7520 NORMAN ISLAND DR

~~CERTIFICATE OF COMPLETION~~ OPERATION PERMIT

INSTALLATION, CONSTRUCTION, ALTERATION, AND/OR REPAIR APPROVAL

APPLICATION FOR IMPROVEMENT PERMIT FOR RESIDENTIAL SITE INDIVIDUAL WATER AND WASTEWATER SYSTEMS PROGRAM

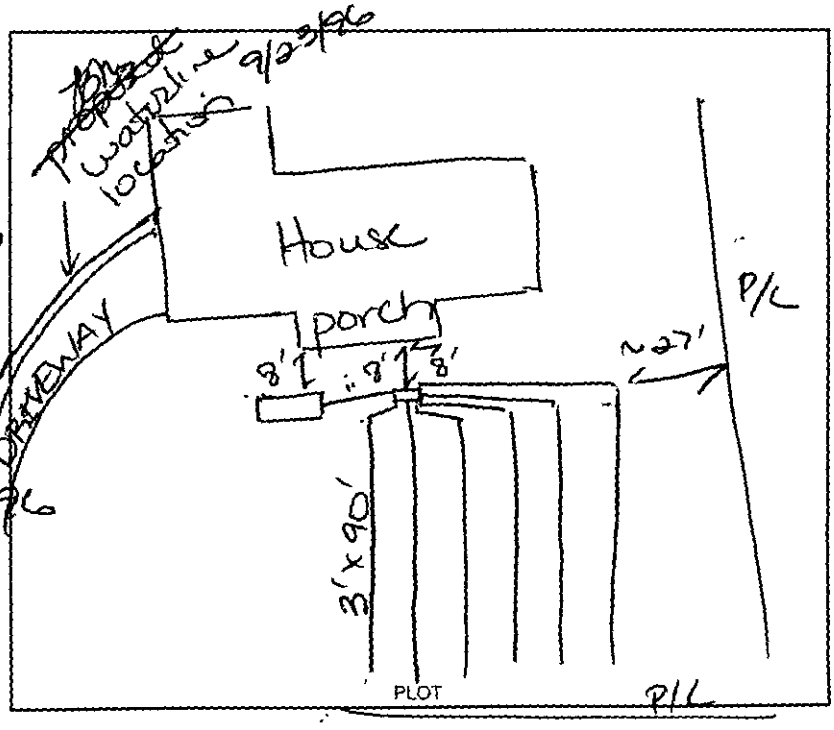
COMMENTS: Type ~~IV~~ II, 4 bedroom house

PROPOSED PLOT PLAN

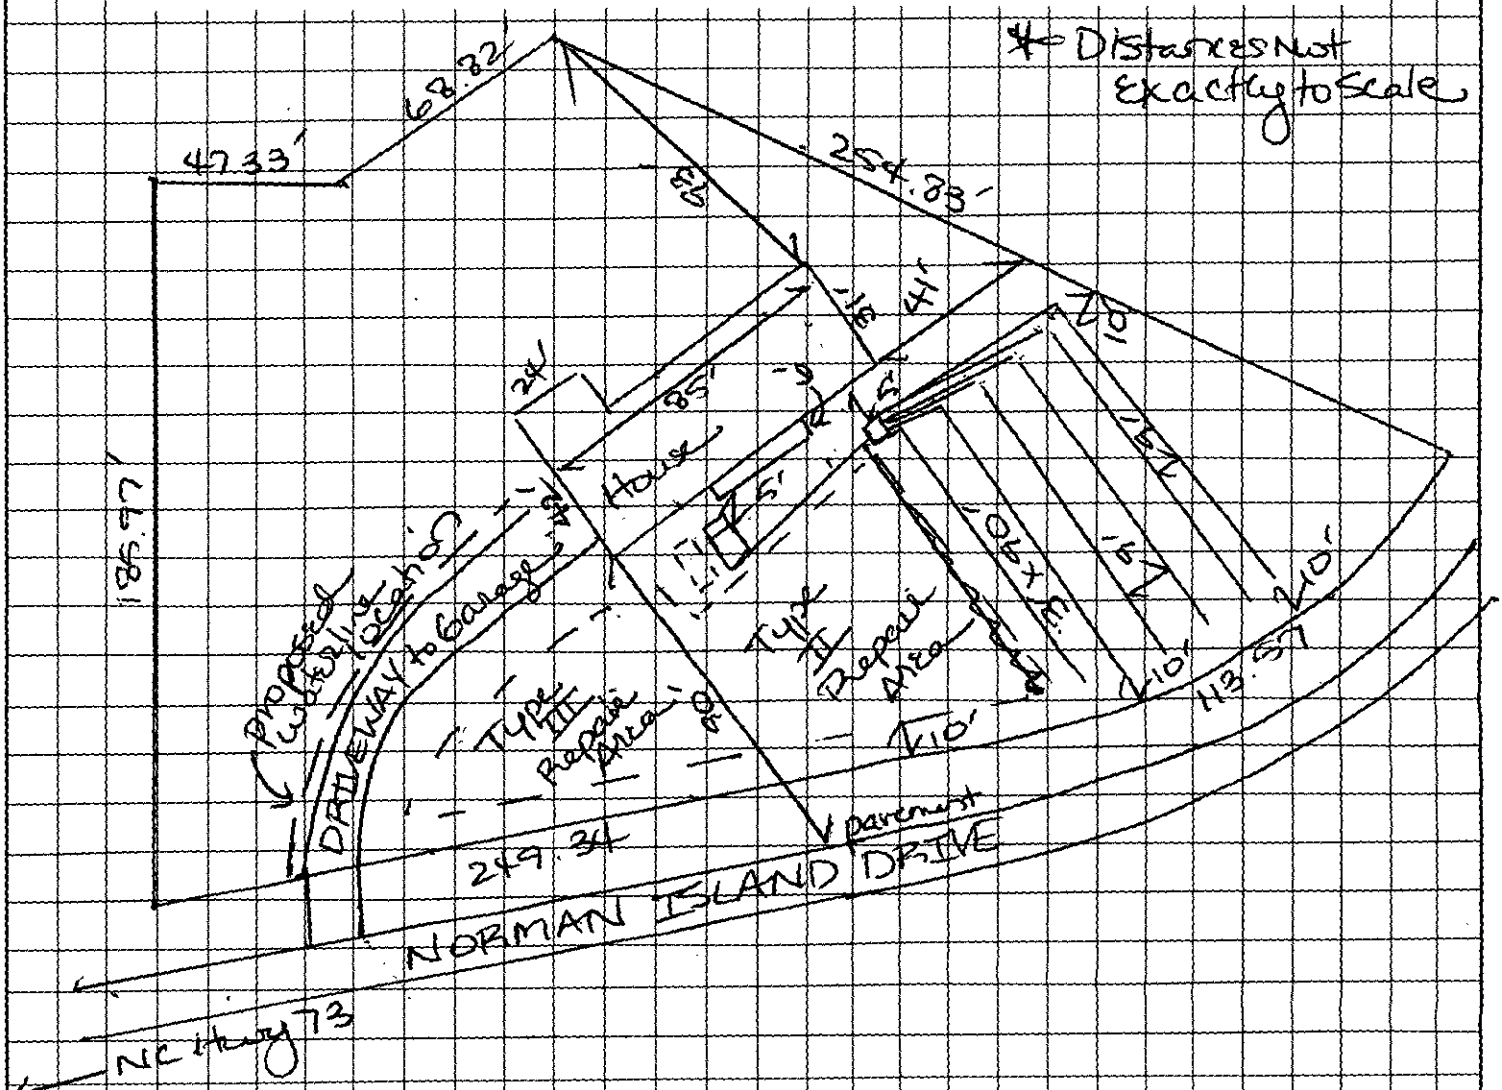
Installation for 4 Bedroom house without basement to be located at 7520 Norman Island Drive.
- See conditions of Improvement Permit
- Plumb house high to accommodate shallow placement of septic tank. Install nitrification lines on contour.
- Waterline shall be 10' minimum from septic tank system & its designated repair area.
